**UNITED STATES
NUCLEAR REGULATORY COMMISSION**
WASHINGTON, D.C. 20555-0001

**SUBJECT: WOLF CREEK GENERATING STATION, UNIT 1 – SAFETY EVALUATION
REGARDING IMPLEMENTATION OF MITIGATING STRATEGIES AND
RELIABLE SPENT FUEL POOL INSTRUMENTATION RELATED TO ORDERS
EA-12-049 AND EA-12-051 (CAC NOS. MF0788 AND MF0781)**

Figure 1 - Wolf Creek SFP Levels of Monitoring

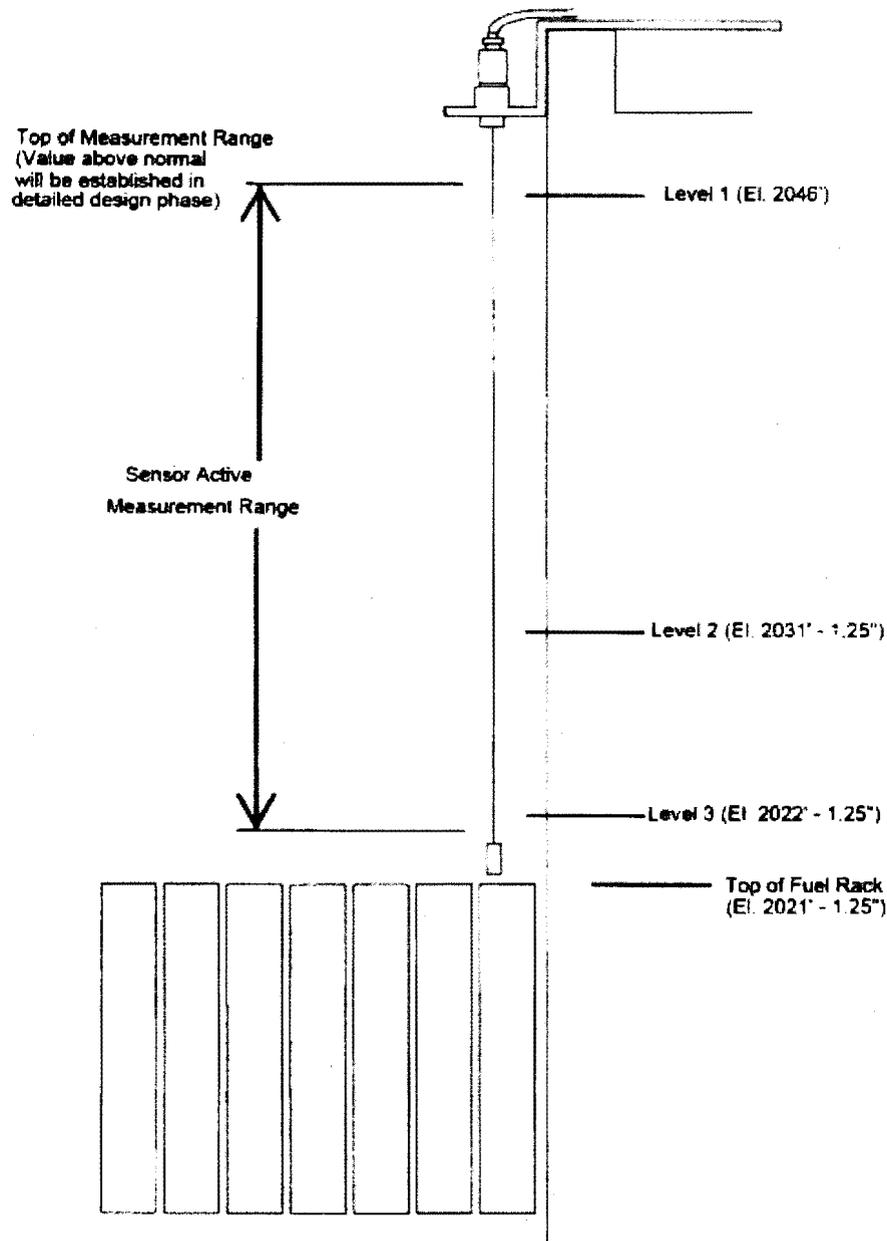
The NRC staff's assessment of the licensee's selection of the SFP levels of monitoring is as follows:
